To: All Plan Holders & Bidding Contractors  
From: Integrity Construction Services, LLC. (Construction Manager)  
Date: September 19, 2017  
Re: Otsego County Library Expansion

## Addendum No. 1

Addendum Number: 1  
Date: September 19, 2017  
Project Name: Otsego County Library Expansion  
SG Project Number: 515747  
Proposal Date: Unchanged

## Palisade Single Contour Redwood Bench

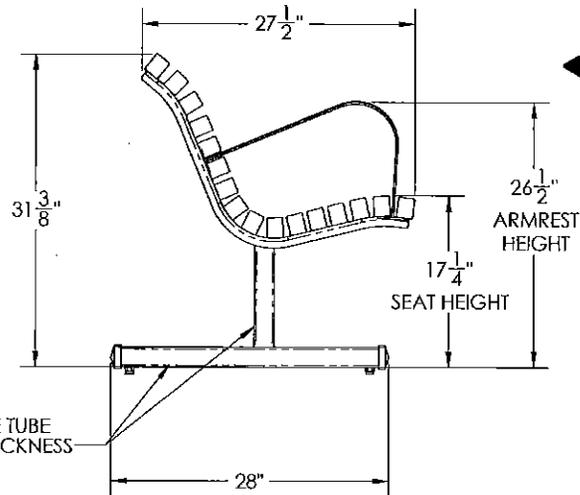
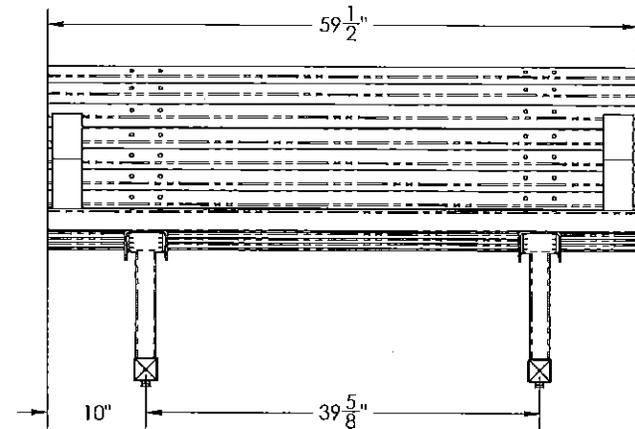
1. Q. – Plumbing insulation specifications.  
**A. – See attached Sheet P-000.**
2. Q. – Flag pole and site furnishings specifications.  
**A. – See attached document labeled 'Site Furnishings'**

Sheet Number: **FP-200**

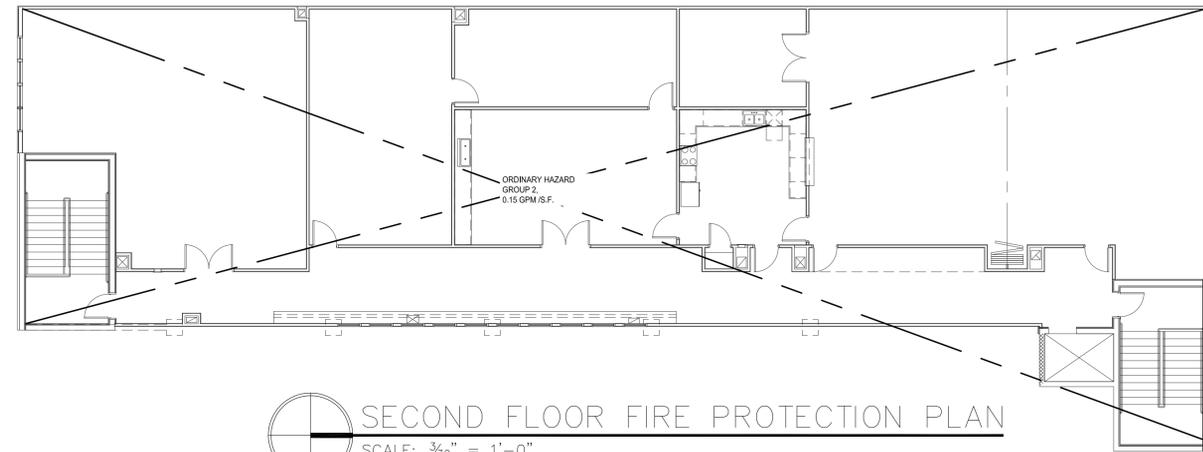
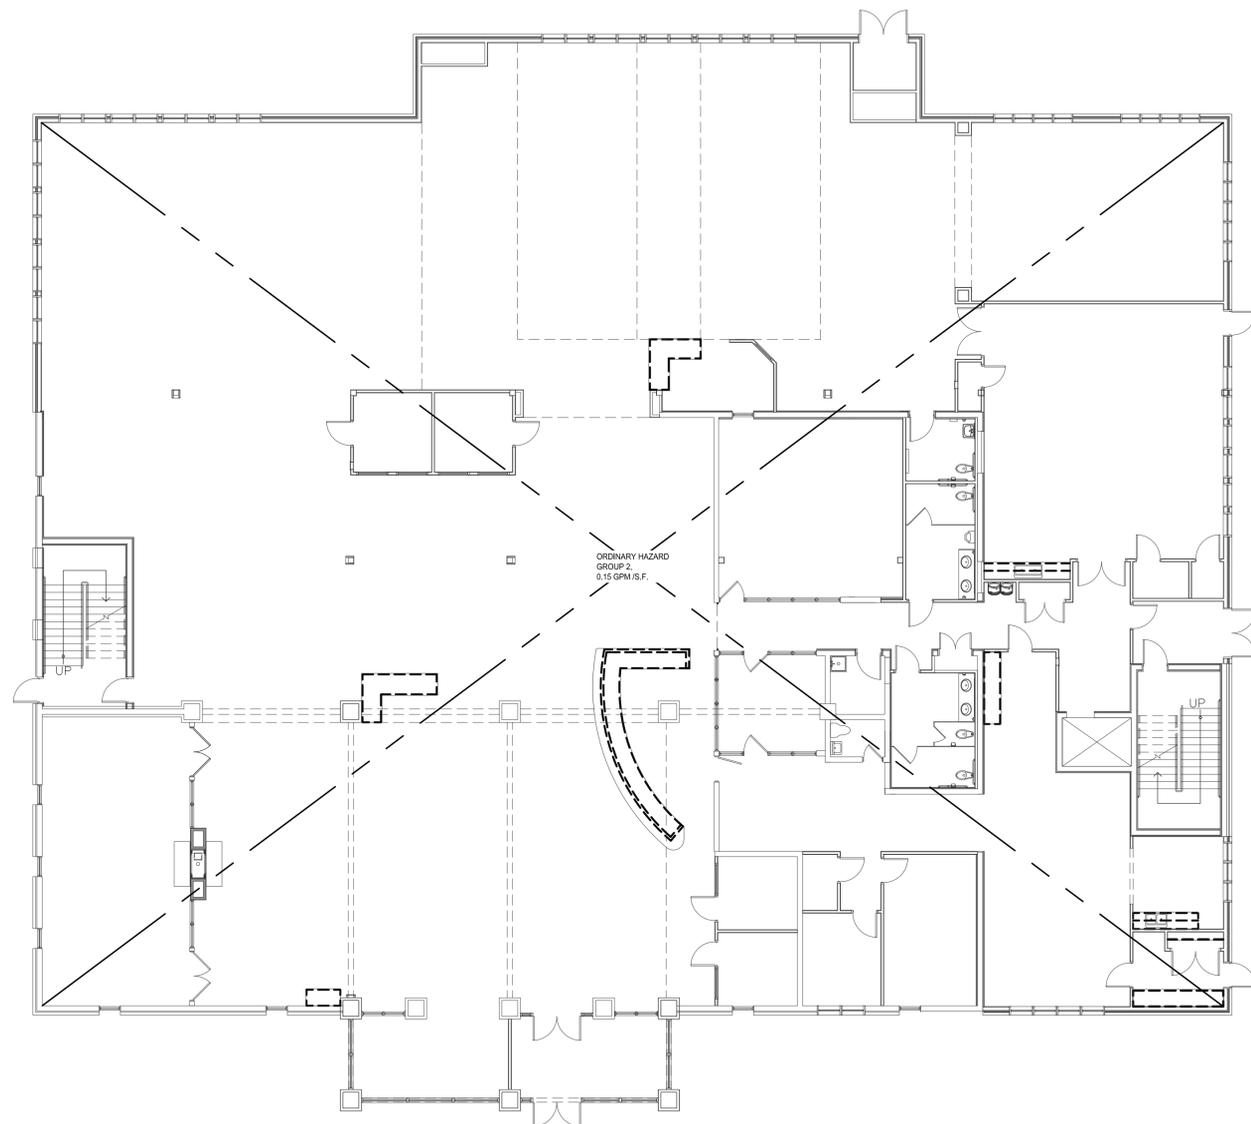
4. Q. – The riser detail on FP-200 shows an RPZ in a vertical position which is not permissible; will there be enough room in RM 125 to install the RPZ horizontally?

**A. – Room 125 shall house only wet standpipe and hose connection devices. Room size is adequate.**
6. Q. – The note on FP-200 says to use existing system where possible, yet there is no existing system. Please clarify.

**A. – The riser detail has been removed; refer to sheet FP-200. The fire protection contractor shall be responsible for the entire system design.**
5. Q. – Is RM 125 large enough to house the required wet and dry system equipment?

**A. – Reference to the use of existing system has been removed.**
7. Q. – What is the height of the operable partition?  
**A. – The height of the operable partition is 7'-6".**
